Proposal Request

PROJECT: *(name and address)*
AWSOM
Bentonville, Arkansas

Architect's Project Number: 993A
Proposal Request Number: 032
Proposal Request Date: 03.21.24

PROPOSAL REQUEST 032 Additional Roof Drain (+ RFI 274)

1 Materials Plan - Roof 2
Scale: 1/8" = 1'-0"

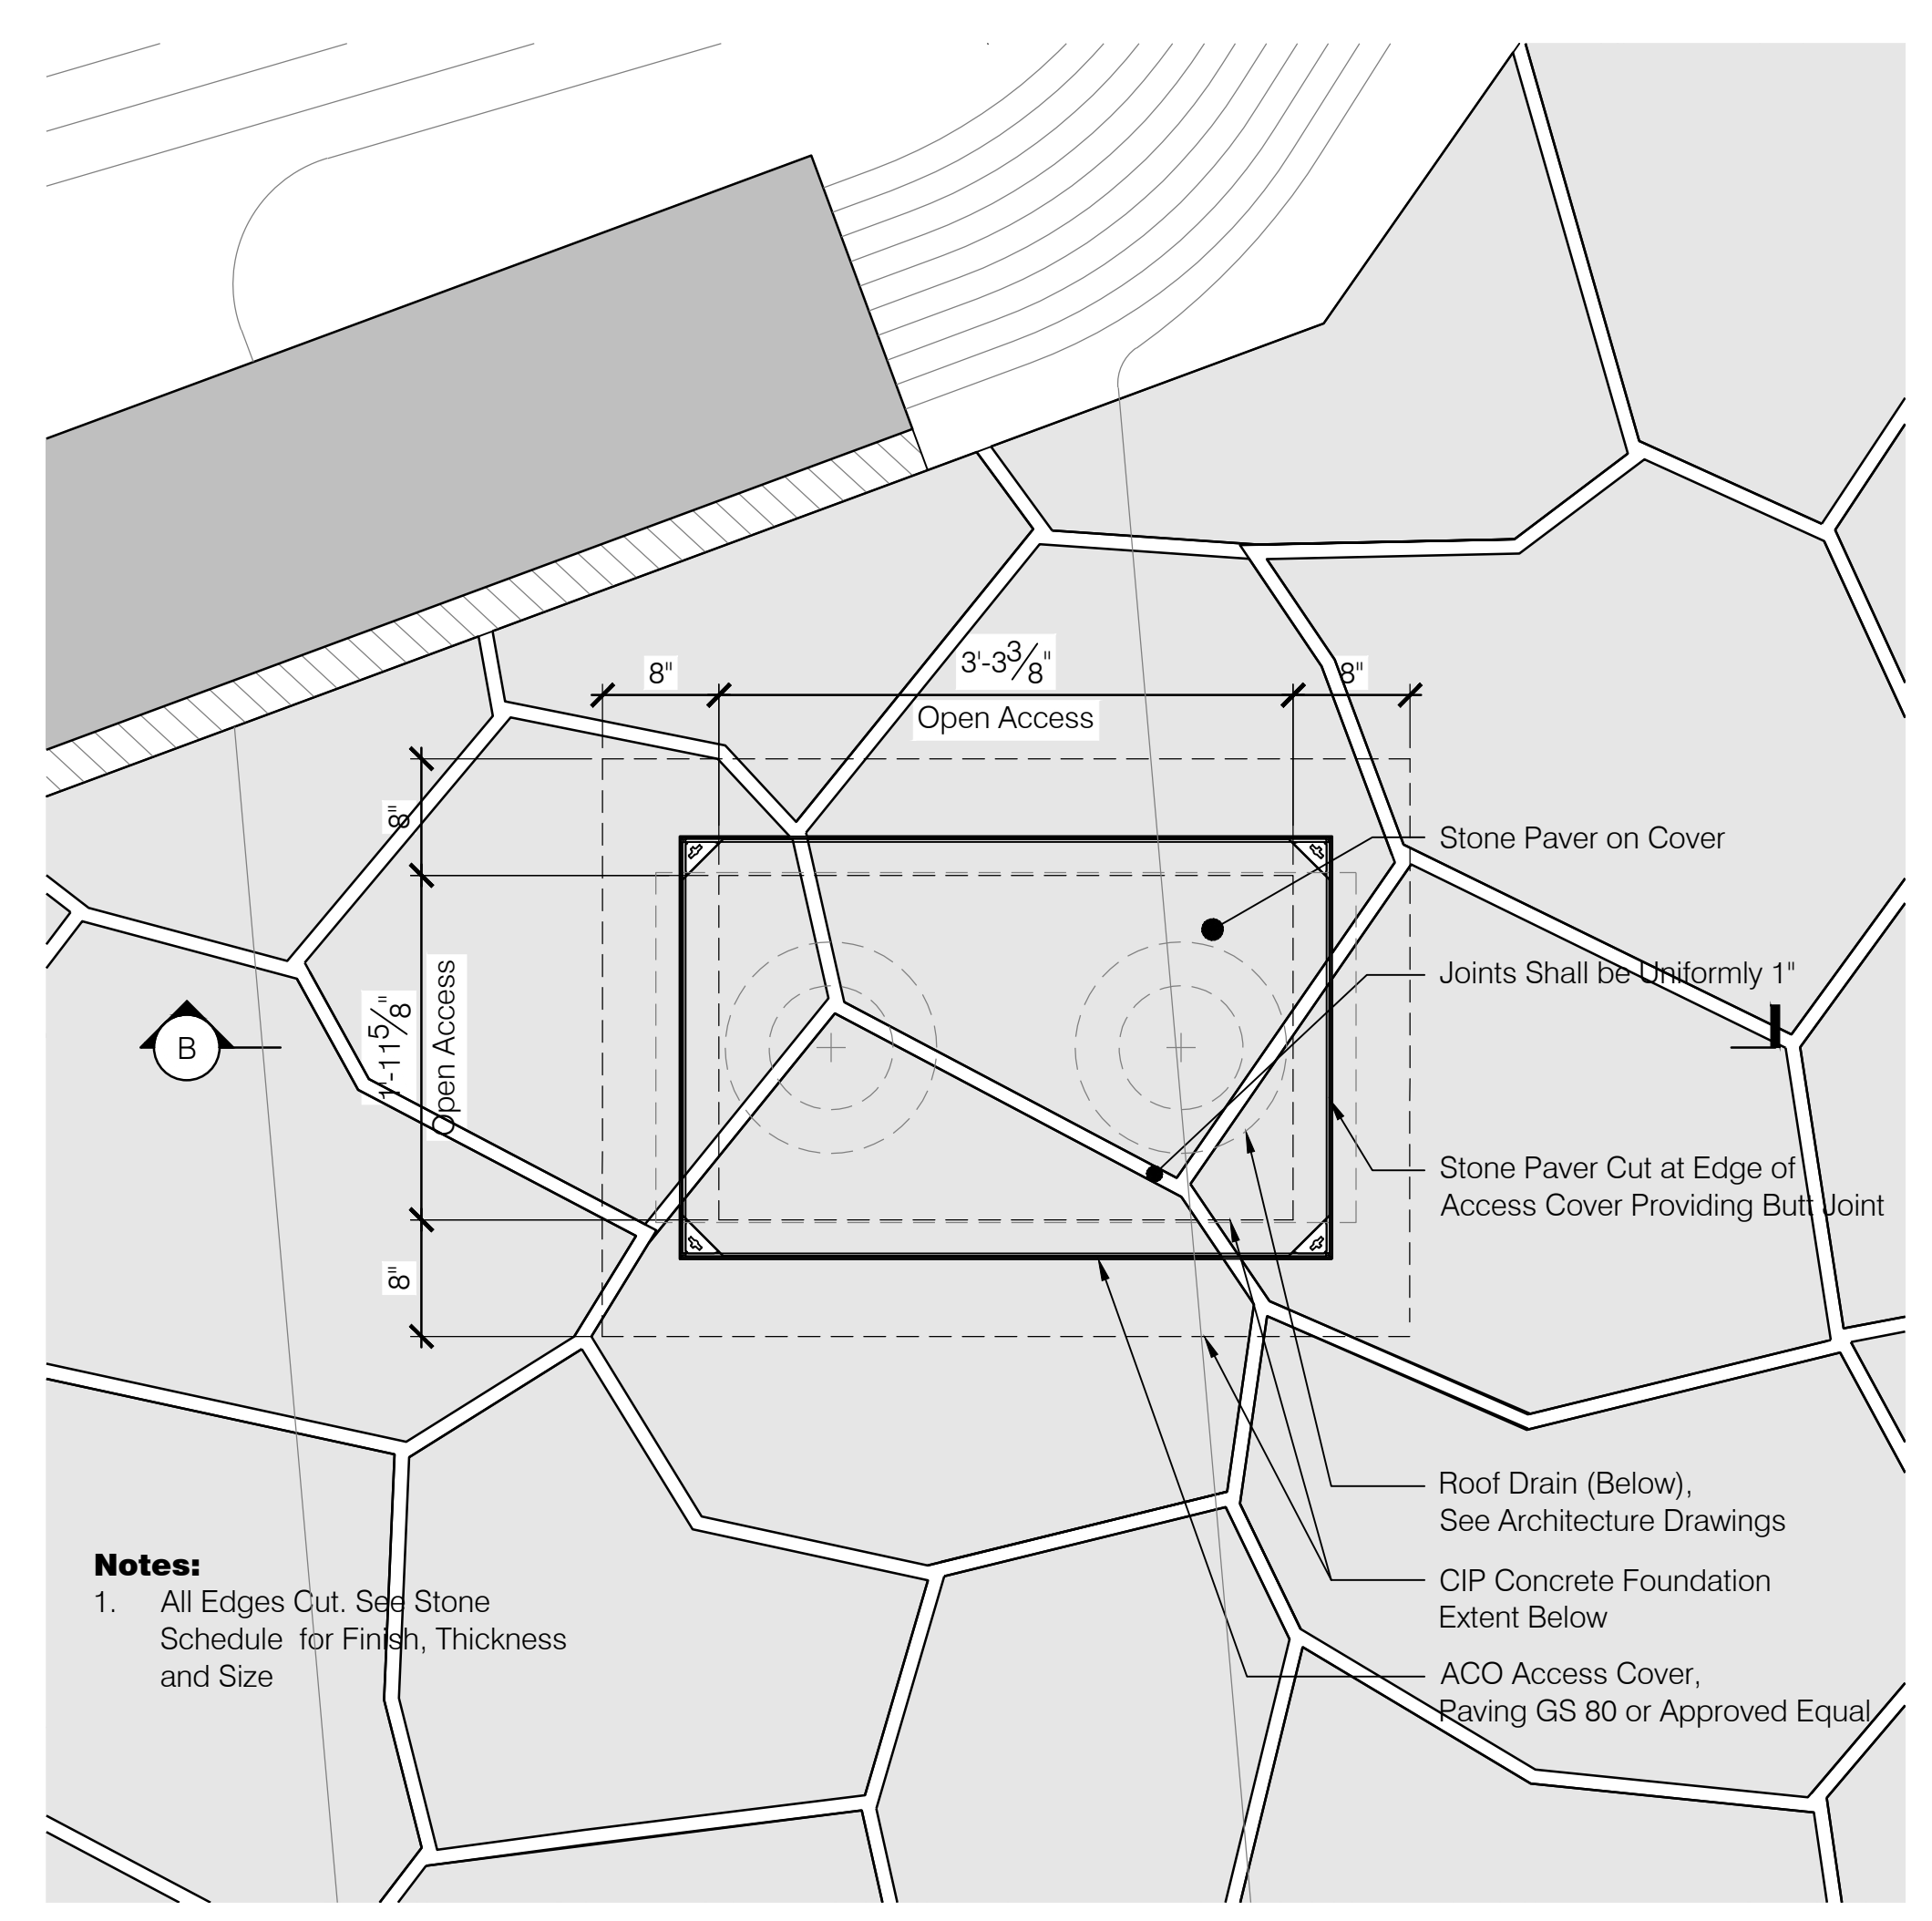
- a) Refer to Revised Sheet **L105**, with original issue date 03.13.2023 and revised date 03.21.2024.
 - Added roof drain south of stairway 12.
 - Updated stonework surrounding all roof drains (2/L913 Roof Access Drain – Type 2 [Landscape]).
 - At grade manhole expression added to all landscape roof drains (2/L913 Roof Access Drain – Type 2 [Landscape]).
- b) Refer to Revised Sheet **L913**, with original issue date 03.13.2023 and revised date 03.21.2024.
 - Updated (2/L913 Roof Access Drain – Type 2 [Landscape]) to reflect manhole access and updated stonework.

1 LEVEL 4 - SLAB EDGE PLAN
 1/16" = 1'-0"

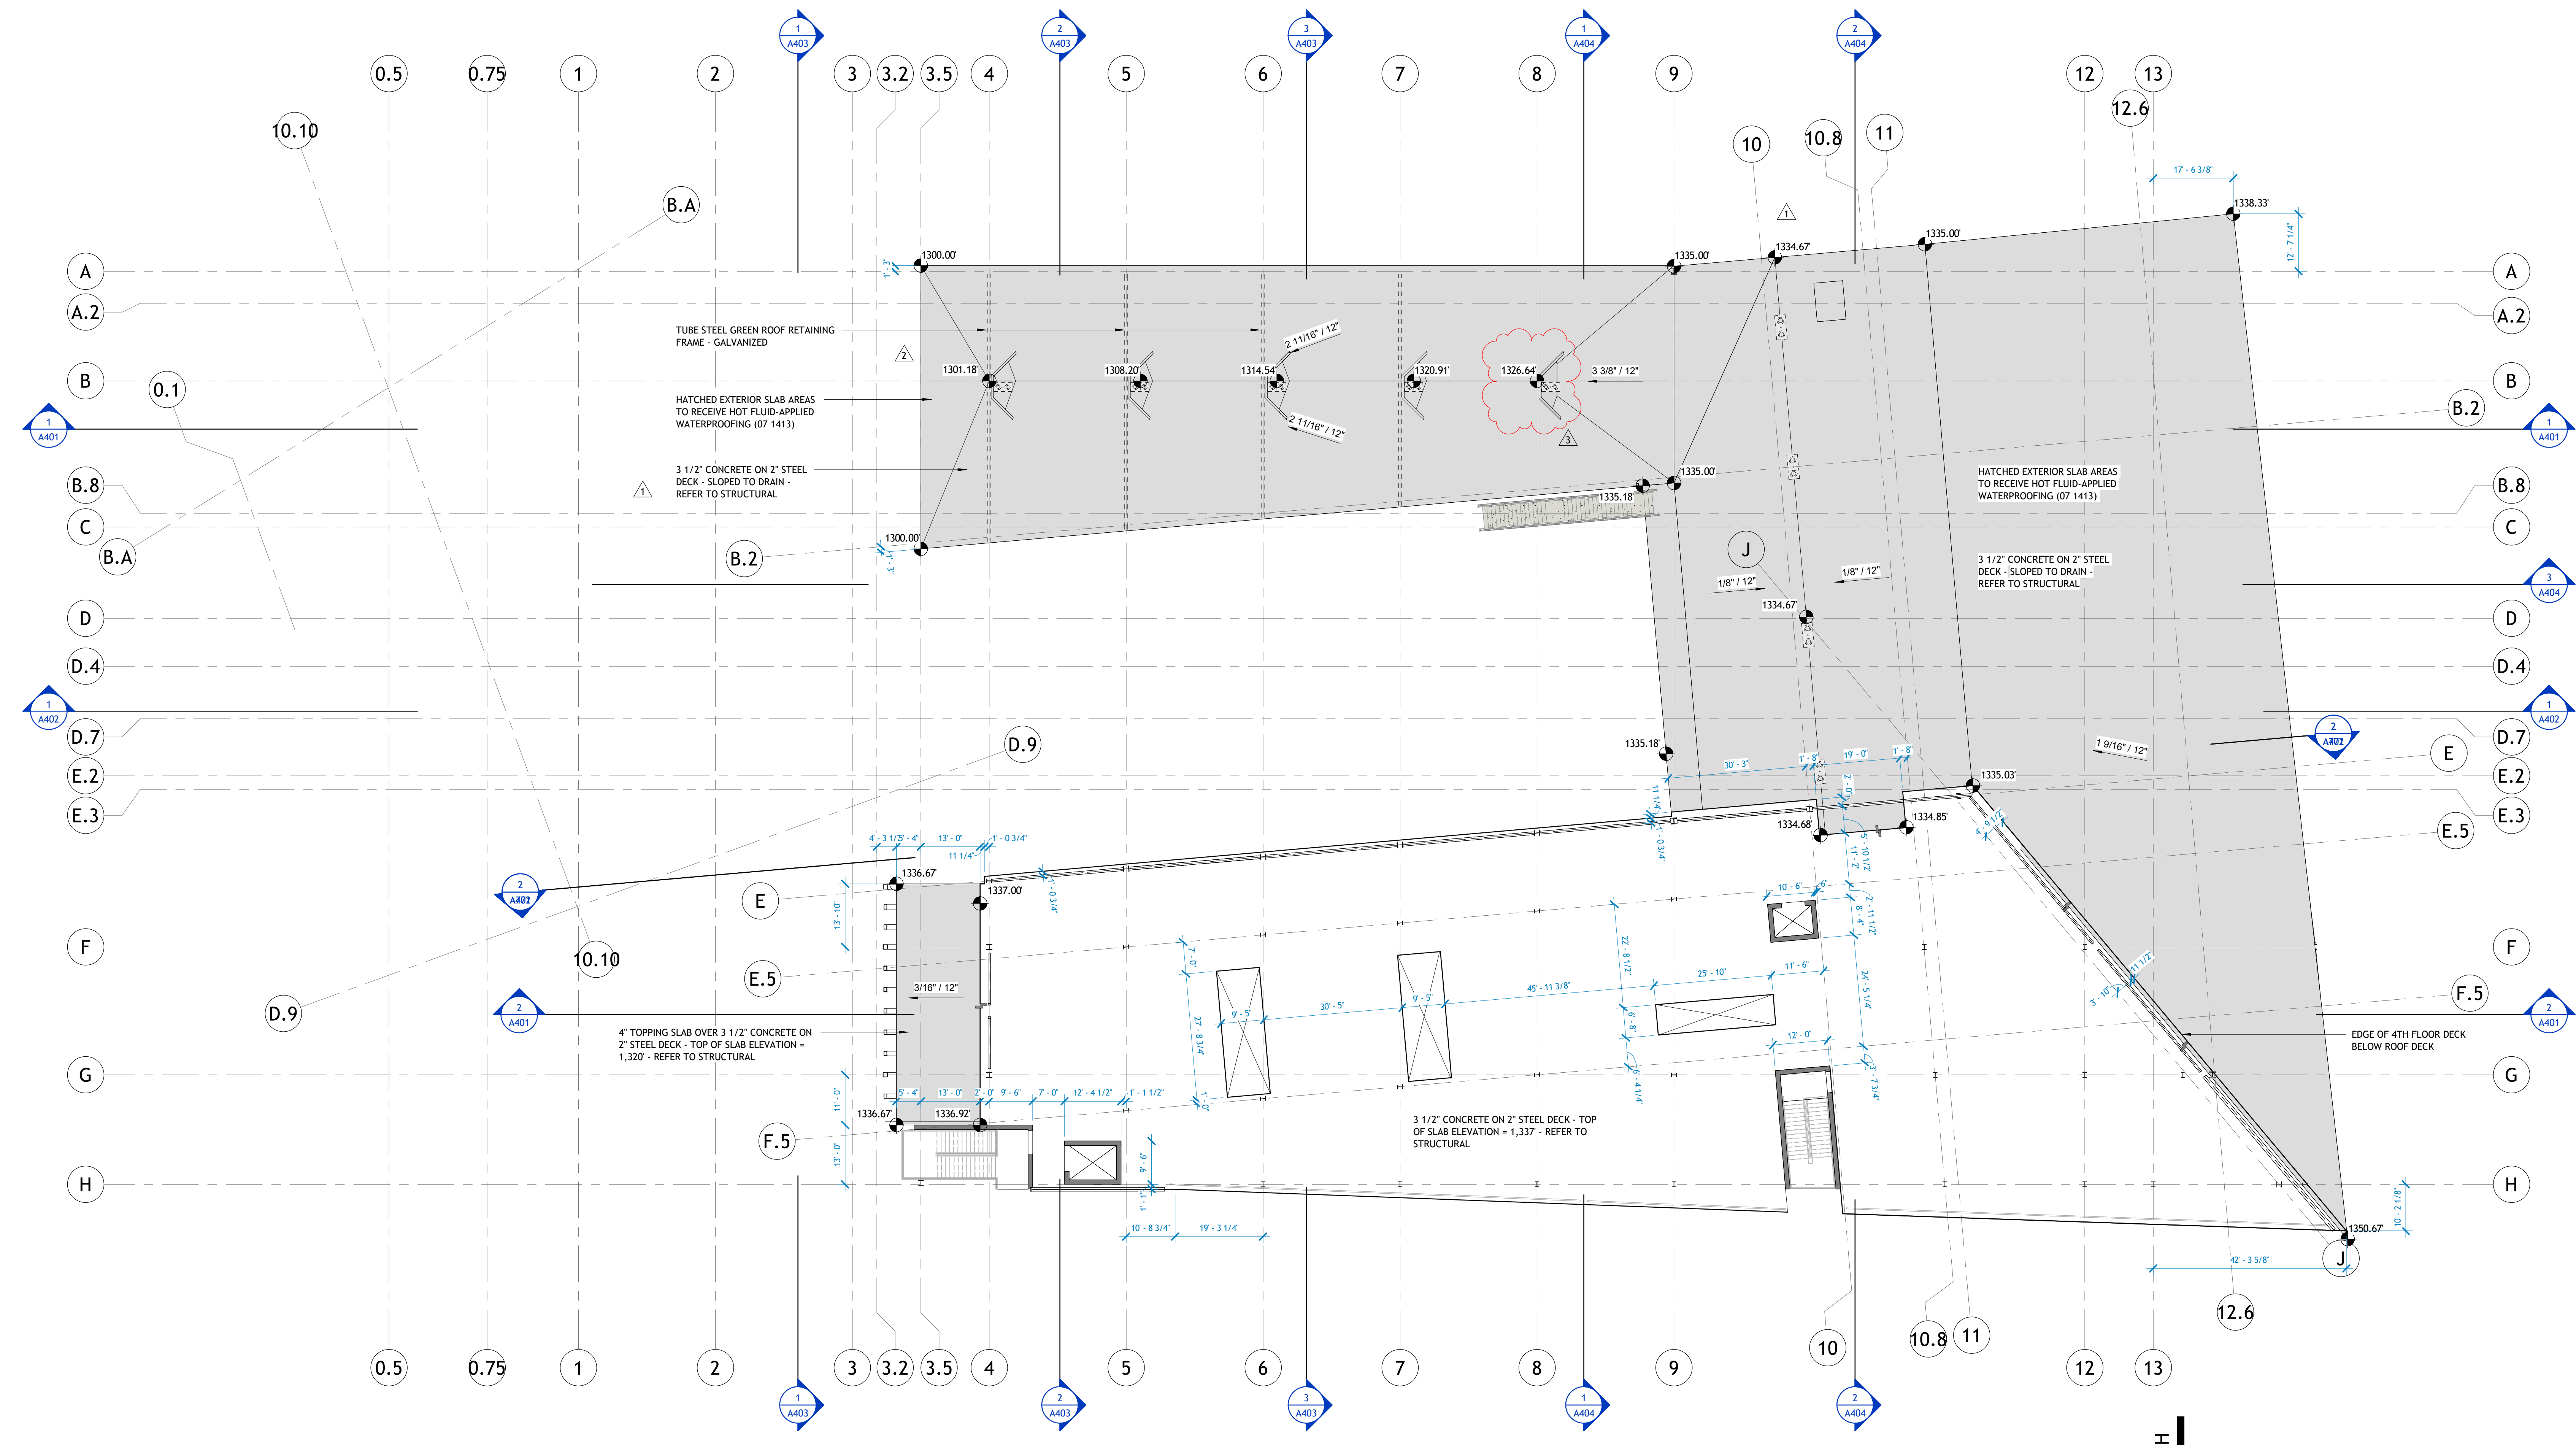
- a) Refer to Revised Sheet **A104S**, with original issue date 02.24.2023 and revised date 03.21.2024.
 - Added roof drain near GL B8.
- b) Refer to Revised Sheet **A105**, with original issue date 02.24.2023 and revised date 03.21.2024.
 - Added roof drain near GL B8.

1 PLUMBING WASTE & VENT - LEVEL 3 PLAN - AREA A
1/8" = 1'-0"

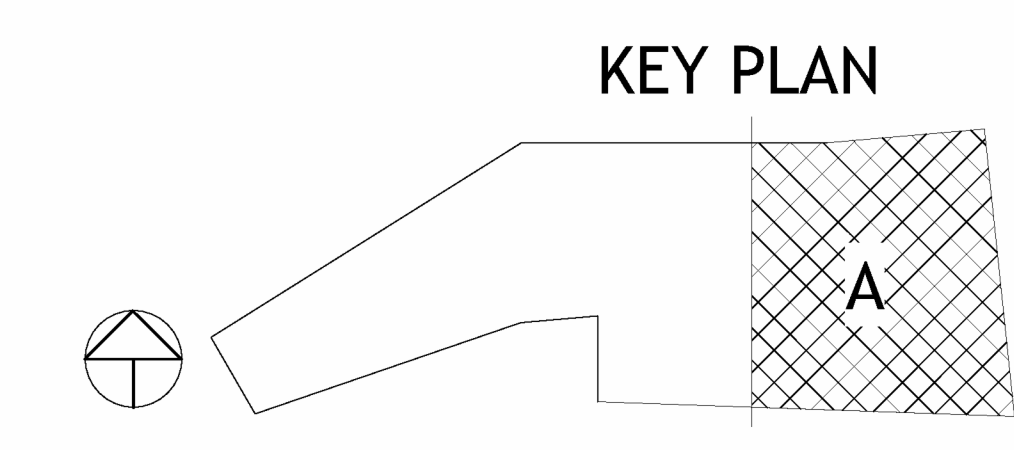
- Added piping to serve shifted roof drains at column line #7.
- d) Refer to Revised Sheet **P105A**, with original issue date 02.24.2023 and revised date 03.21.2024.
 - Added roof drains at column line #4.
 - Shifted roof drains at column lines #5, #6 & #7.
- e) Refer to Revised Sheet **P200**, with original issue date 02.24.2023 and revised date 03.21.2024.
 - Added piping to serve new roof drains at column line #4.

1 PLUMBING WASTE & VENT - LEVEL 2 PLAN - AREA A
1/8" = 1'-0"

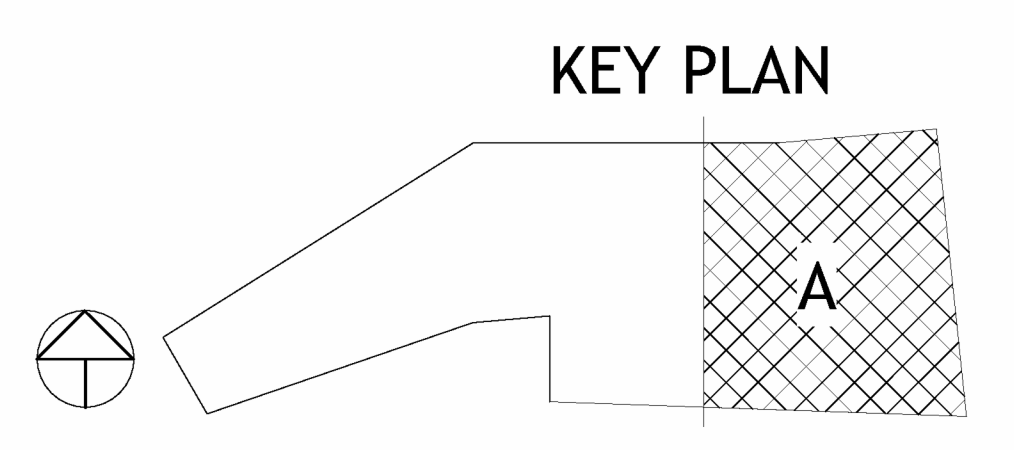
- a) Refer to Revised Sheet **P101A**, with original issue date 02.24.2023 and revised date 03.21.2024.
 - Added piping to serve new roof drains at column line #4.
- b) Refer to Revised Sheet **P102A**, with original issue date 02.24.2023 and revised date 03.21.2024.
 - Added roof drains at column line #4.
 - Updated piping for roof drain location shift at column lines #5, #6 & #7.
- c) Refer to Revised Sheet **P103A**, with original issue date 02.24.2023 and revised date 03.21.2024.
